SUBJECT: Forwards response to 840813 request for addl. info re
 proposed amend to spent fuel facility expansion.

Re: Turkey Points Units 3 & 4
Docket Nos. 50-250 & 50-251
Proposed Amendment to
Spent Fuel Storage Facility Expansion
Additional Information

FLORIDA POWER & LIGHT COMPANY
TURKEY POINT UNITS 3 & 4
PROPOSED AMENDMENT TO
SPENT FUEL STORAGE FACILITY EXPANSION
REQUEST FOR ADDITIONAL INFORMATION

FIGURE 1

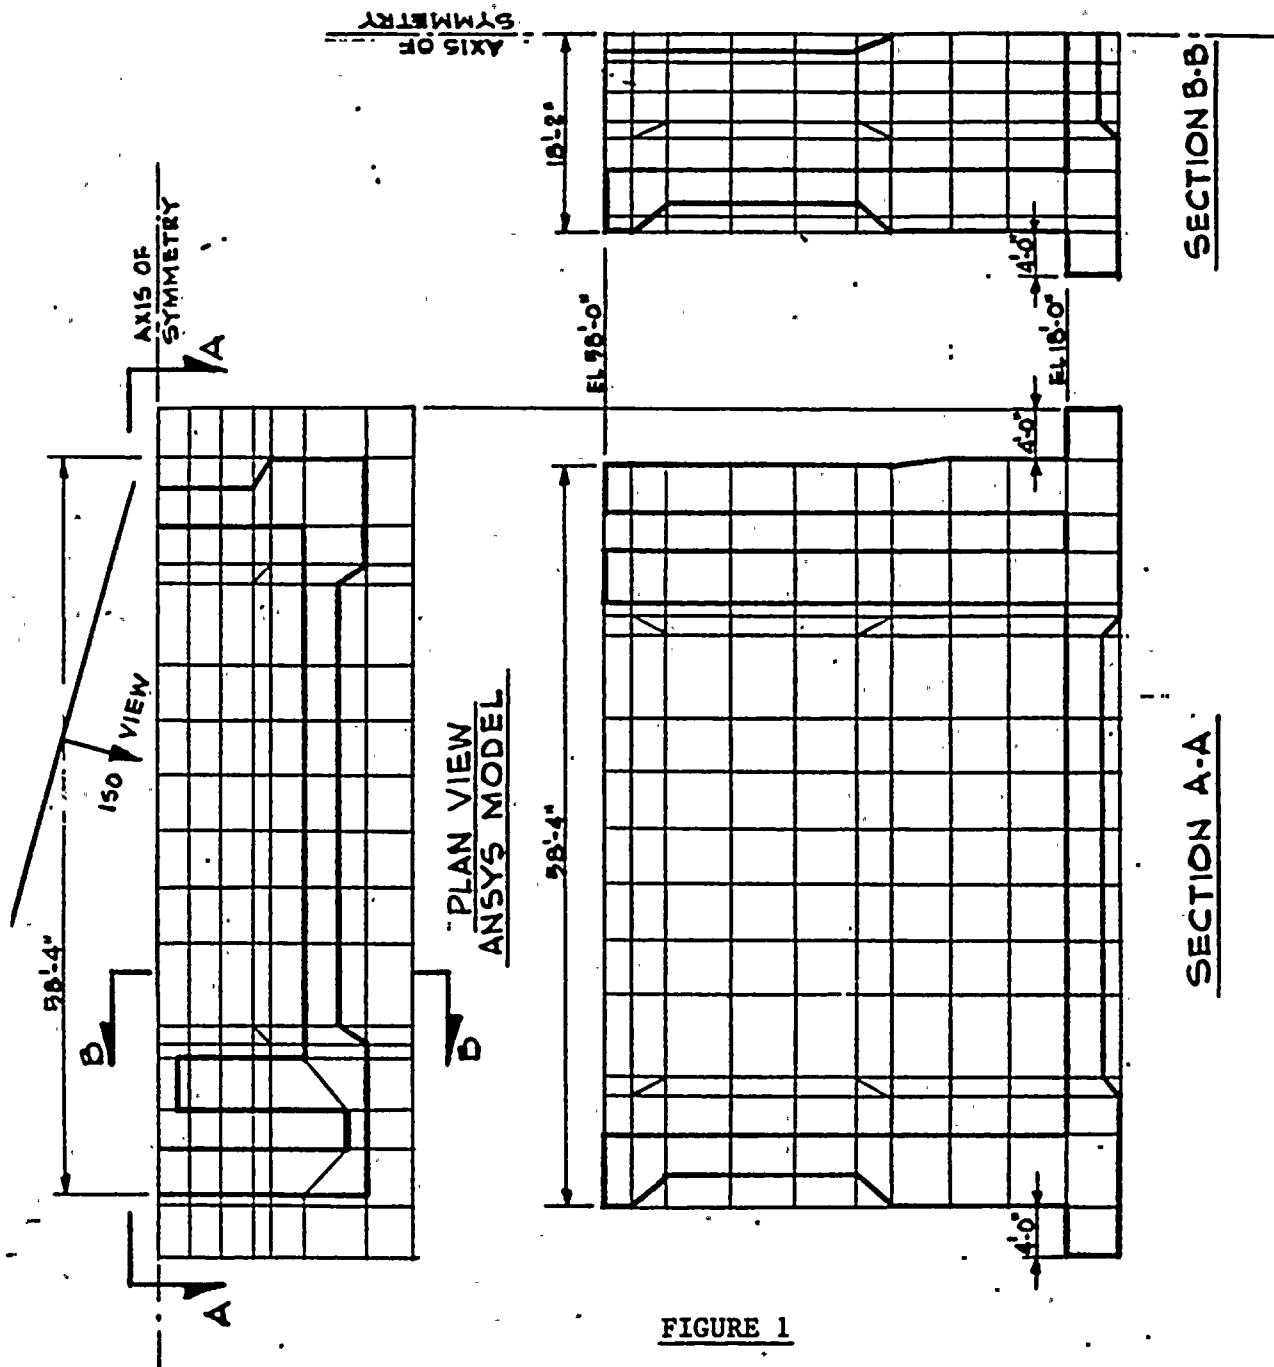
9. Please provide more detailed information about the finite element model of spent fuel pool structure including the stainless steel liner plate elements and how it is connected to the pool walls and foundation mat.

RESPONSE: The spent fuel pool is modeled using three-dimensional solid elements and the ANSYS computer code (Reference 1). Figures 1 through 7 (submitted in response to Question 10) define the model geometry. Due to symmetry along the long direction of the pool (north-south), only half the pool is modeled. A minor geometrical dissymmetry occurs at the west end of the canal area where the spent fuel enters from the reactor building (see Updated FSAR Appendix 14E, Figure 3.1-3). This minor dissymmetry has negligible effect on the structural behavior of the model considered. Conservatively, the stainless steel liner is not considered in the model. The model is supported vertically on a bed of compression spring elements representing the soil stiffness under the structure. (Section 4.5.1 of the Spent Fuel Pool Rerack Safety Analysis Report incorrectly states that the foundation's support is represented by solid elements.)

FIGURE 3

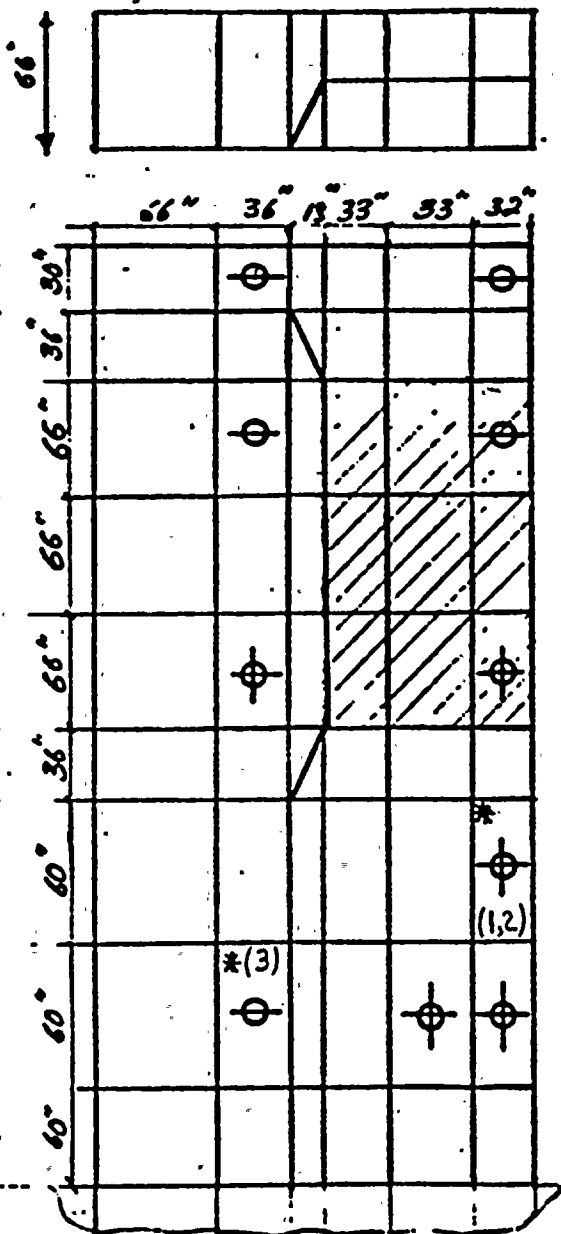
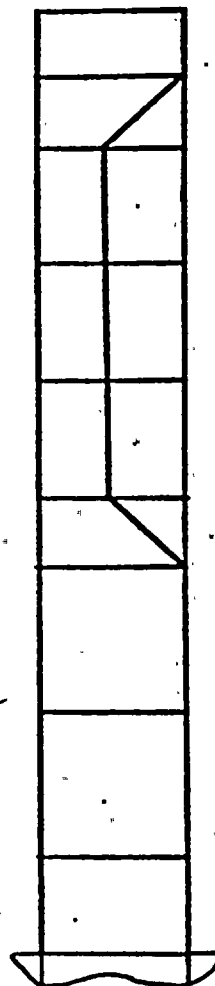
10. Please provide a summary of the stress analysis of the spent fuel pool structure (walls, foundation mat, and liner plates), also the bearing stress of the soil and bed rock supporting the pool.

Representative critical elements of the finite element model in the base mat and all walls were identified based both on high stress results and locations which result in severe loading. These elements are shown in Figures 3 through 7 and were further evaluated in the manner described below:

A summary of the controlling stresses is provided in Table A for the locations identified in Figures 3 through 7. These stresses represent maximum stresses for load transfer. Controlling stresses occur in reinforcing steel, except for one instance where concrete shear governs.

FIGURE 2

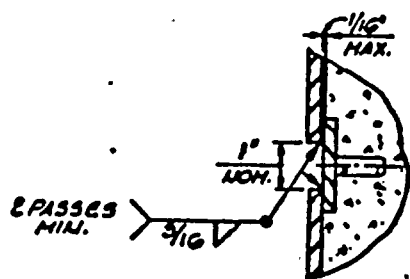
12. Please discuss the design of the weld connections between the stainless steel liner plates.

In support of the leak prevention function, the liner plates are welded to each other or to embedded plates using seam welds which were sized for hydrostatic and thermal loads. Vertical seams in the wall liner plates are square butt or bevel butt welds with embedded $1/4" \times 2"$ continuous bars serving as backing bars (Figures 1 and 2). Horizontal seams in the wall liner plates are fillet welds between the plate edges and the embedded $1/4" \times 21"$ continuous bars (Figure 3). Seams in the floor liner plate are fillet welds between plate edges and embedded plates or bars. The surfaces of the seams are maintained flush with the floor by use of $1/4"$ square filler bars and bevel filler welds (Figure 4).
